Model: Model-J		Date: 25-Jan-02	No.: MG060001
Modified Article: Parts Catalog Correction		Prepared by: H.Someya	
From: Technical Services Dept., GTS Division			
Reason for Modification:	<input checked="" type="checkbox"/> Parts catalog correction	<input type="checkbox"/> Vendor change	<input type="checkbox"/> To meet standards ()
	<input type="checkbox"/> To facilitate assembly	<input type="checkbox"/> To improve reliability	
	<input type="checkbox"/> Part standardization	<input type="checkbox"/> Other

Model: Model-J P1b		Date: 3-Apr-02	No.: MG060003
Modified Article: Guide Plate – Middle Registration		Prepared by: T. Itoh	
From: Technical Services Dept., GTS Division			
Reason for Modification:	<input checked="" type="checkbox"/> Parts catalog correction <input type="checkbox"/> To facilitate assembly <input type="checkbox"/> Part standardization	<input type="checkbox"/> Vendor change <input type="checkbox"/> To improve reliability <input type="checkbox"/> Other	<input type="checkbox"/> To meet standards ()

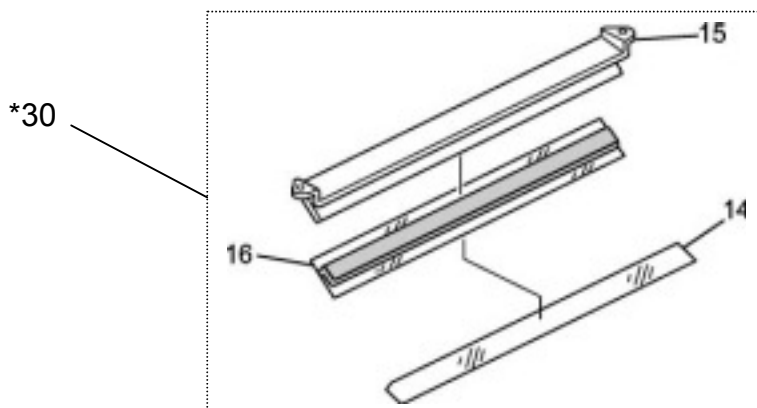
Old part number	New part number	Description	Q'ty	Int	Page	Index	Note
G0601267	G0771267	Right Rear Cover			11	17

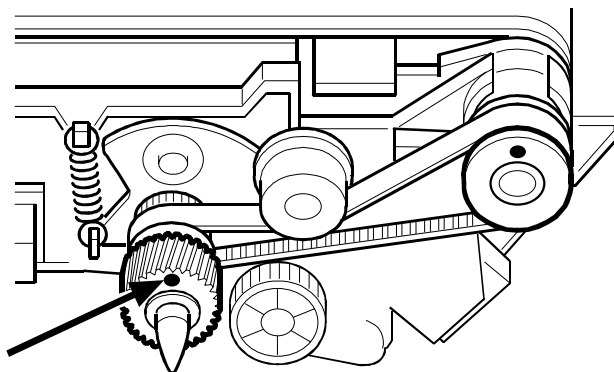
The mark used for adjusting the phase of the Transfer Drive Roller has been incorporated into the part's mold (not applied manually as before).

Old part number	New part number	Description	Q'ty	Int	Page	Index	Note
G0603866	G0603703	Drive Roller	1-1	O/O	39	7

Page 41

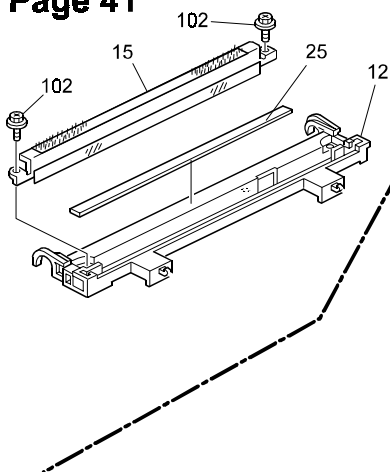
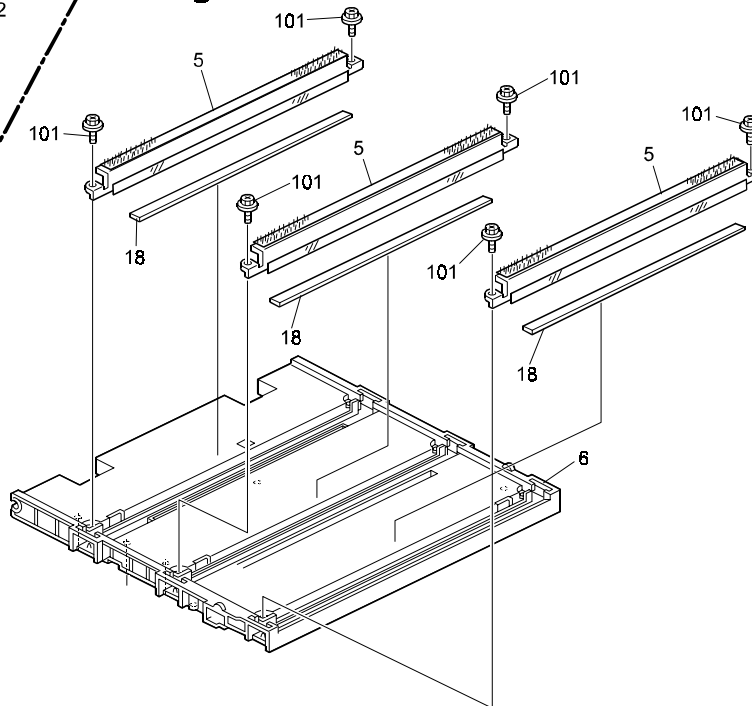
The following cushions have been newly added to absorb the vibration of the Transfer Charge Brushes, which can generate a low humming noise when a toner/dust buildup on the brush fibers increases the friction between the fibers and transfer belt.

On production machines after the cut-in numbers below, the cushions are attached directly onto the unit underneath the brushes. For machines in the field, the cushions should be attached according to the detailed procedure in RTB #RG060009.

Old part number	New part number	Description	Q'ty	Int	Page	Index	Note
	G0603705	Cushion – Transfer Brush	0-1		41	25	new
	G0603705	Cushion – Transfer Brush	0-3		43	18	new

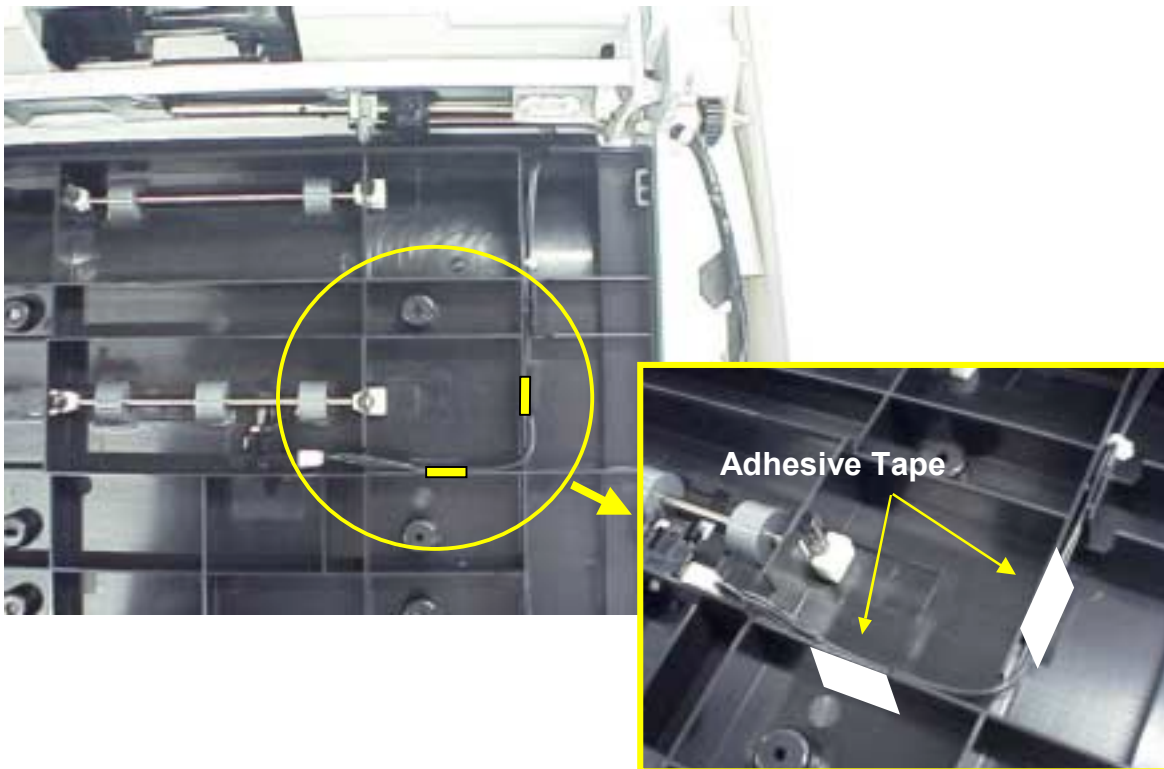
If this tape is necessary in the field, please order using the following (existing) part number:

Part number	Description	Q'ty	Int	Page	Index	Note
G0123897	Film – Toner End Sensor Harness	0-2		23	30	new

25. Drive Section 1 (G060)

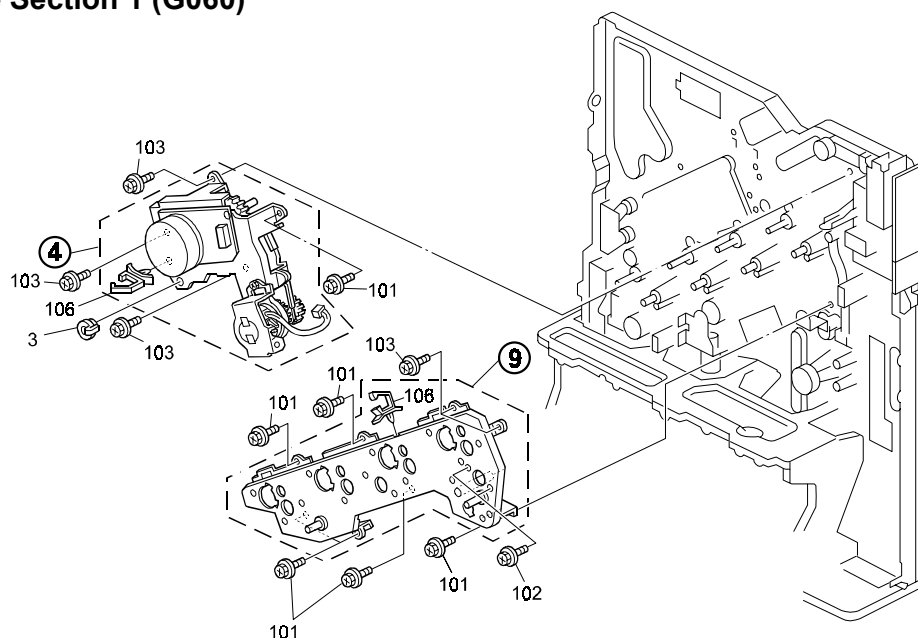
A fusing clutch has been added to the Bk development drive unit, which allows the drive to the fusing unit to be cut off during operations such as process control self-checks, line position adjustments and printer/copier image processing. Since the unit does not need to be running during these operations, the clutch will maximize the field durability of the fusing and oil units.

A DIP switch was added to the BCU board, which instructs the machine to detect or not detect the clutch. Please see RTB #RG060005 for details on the switch settings.

The following components were modified so that the clutch could be added. The new clutch is a component of the drive unit for the Bk development unit.

Note: Although the engine firmware was changed to ver B1.11H, the clutch engage/disengage control program had not been added yet. The clutch is therefore constantly engaged and keeps the fusing unit moving, as before.

The engage/disengage program for the clutch was added to the engine firmware (now ver B1.15E). Aside of the firmware, the BCU board itself remains unchanged.

11. Paper Registration (G060)

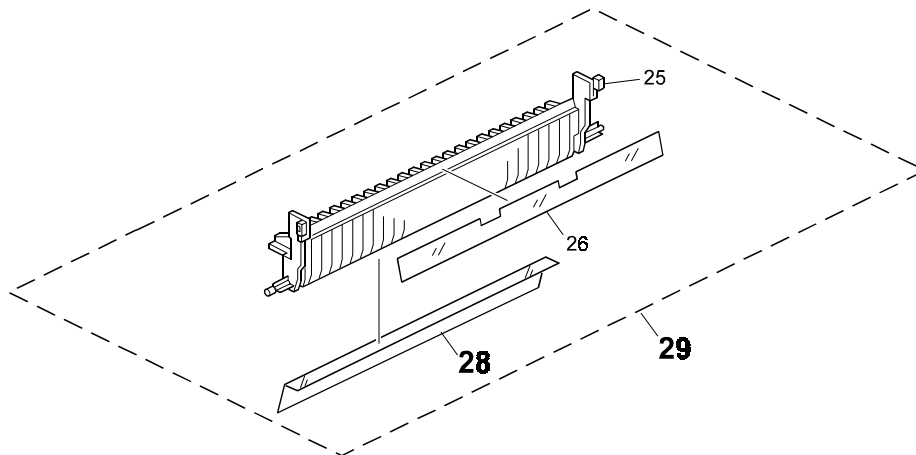
The following parts have been newly registered due to requests from the field.

Old part number	New part number	Description	Q'ty	Int	Page	Index	Note
	G0602633	Guide: Middle: Lower	0 - 1		29	28	New
	G0602618	Guide Plate: Middle: Lower: Adhesion	0 - 1		29	29	New

7. 2nd Paper Feed Section (G060)

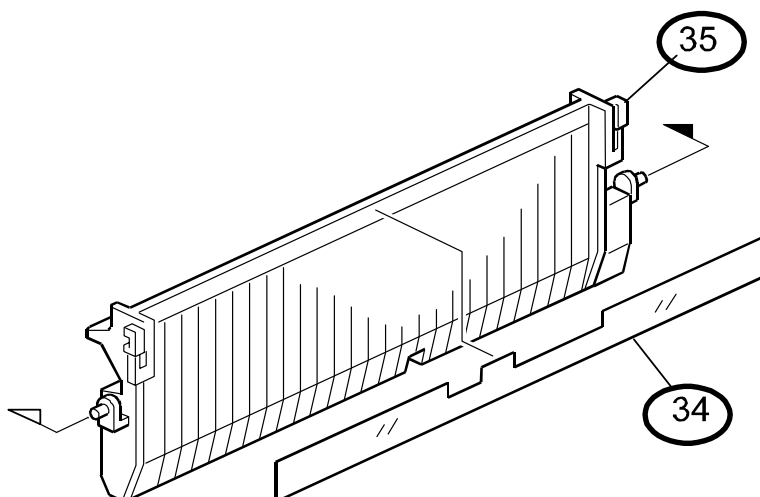
Please apply the following index corrections in the illustration to your Parts Catalogs.

Part number	Description	Page	Index
G0602629	Vertical Transport Guide	21	34
G0602730	Guide Plate	21	35

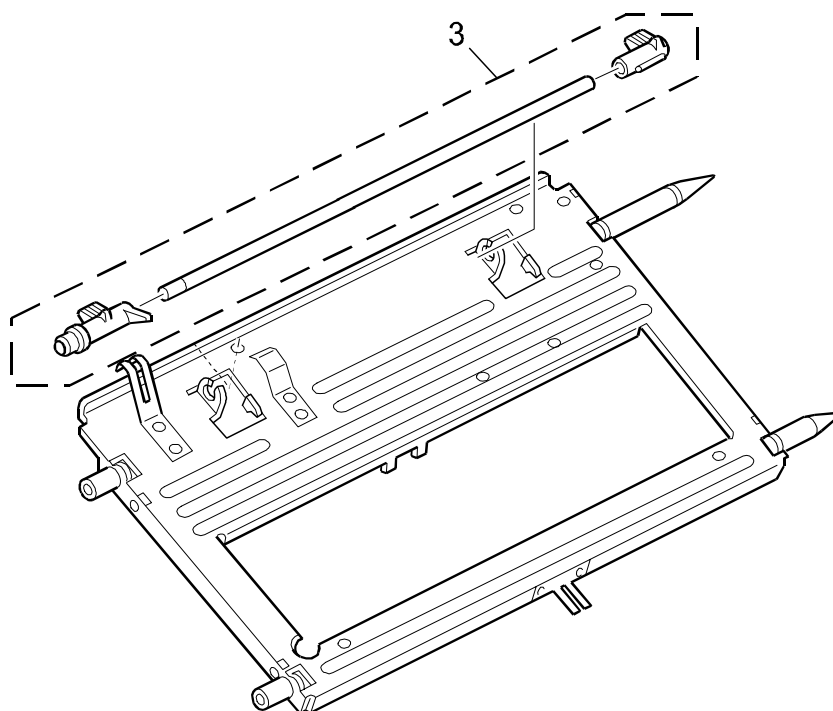
Delete the following P/N, descriptions and indexes from the illustration.
 These springs were deleted because they are provided only as part of the G0603694 Release Shaft (index 3 below), not individually.

Old part number	New part number	Description	Q'ty	Int	Page	Index	Note
AA066344		Rear Torsion Spring	1 - 0		41	23	
AA066345		Front Torsion Spring				24

17.Transfer Unit 3 (G060)

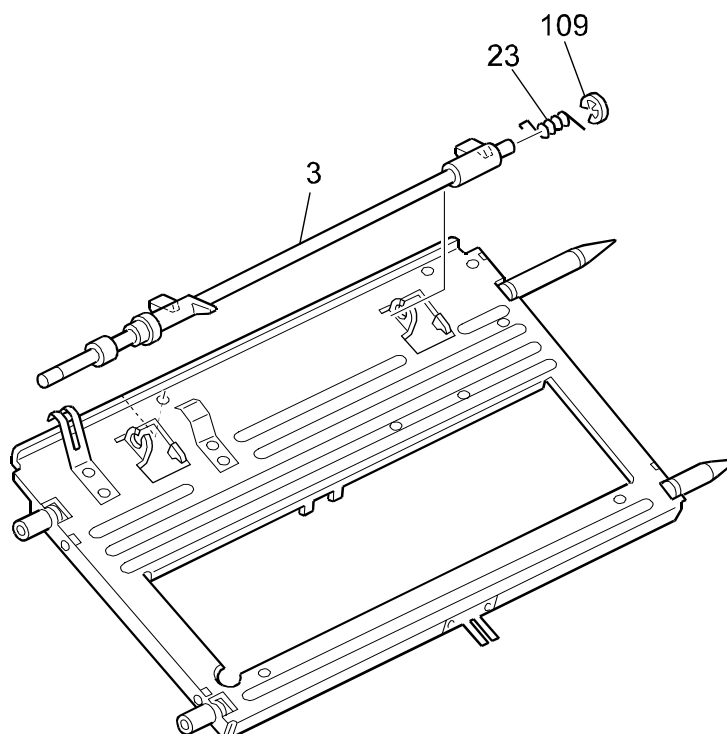
- 1) The machine is now shipped with the drum released from the transfer belt, i.e. with the release lever secured with tape in a second (new) unlocked position.
- 2) The parts listed below have been modified so that the front door can be closed with the lever in the second unlocked position for shipping. At installation, the lever must then be set to the locked position for the door to close.

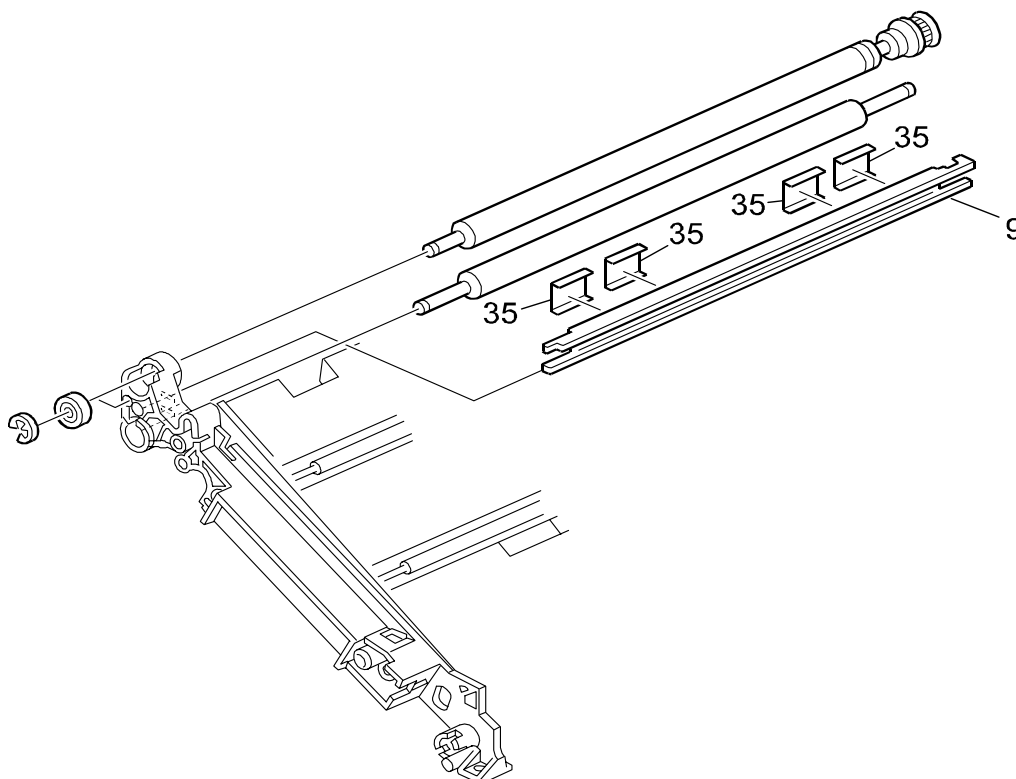
The following sheet has been added to ensure a proper gap between the Left Stay and Transfer Belt, as toner accumulated on the stay from toner scattering can be transferred to the transfer belt and cause an ID sensor misdetection.

Note: The four sheets are attached to the Left Stay, just to the left and right of both ID sensors (see illustration below).

Old part number	New part number	Description	Q'ty	Int	Page	Index	Note
G0603840	G0603841	Transfer Unit	1 – 1	X/O	37	19	
	G0603707	Sheet: Stay: Left	4		39	35	NEW

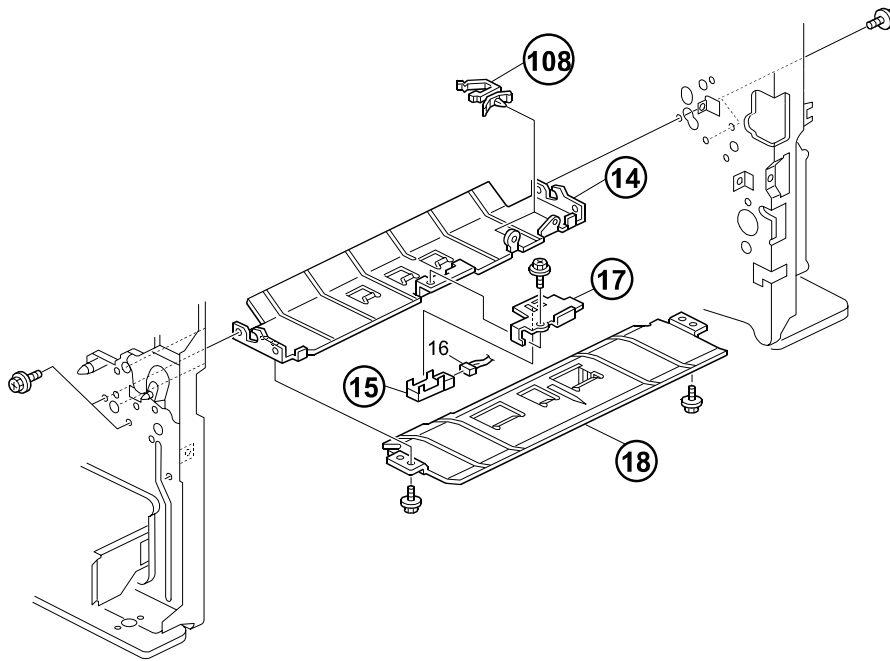
The following have been changed due to parts standardization with the J-P2. In addition, these new parts further ensure that the harness is led properly.

Old part number	New part number	Description	Q'ty	Int	Page	Index	Note
AW020096	AW010098	Photointerrupter - GP2A231LRSA	1 - 1	X/X	29	15	*1
G0602625	G0802621	Guide Plate:Duplex:Exit:Upper	1 - 1	X/X	29	14	*1
G0602622	G0802622	Guide Plate:Duplex:Exit:Lower	1 - 1	X/X	29	18	*1
G0602634	G0802635	Bracket:Sensor:Paper Feed	1 - 1	X/X	29	17	*1
	11050511	Harness Clamp - LWS - 0306ZC	2		29	108	New *1
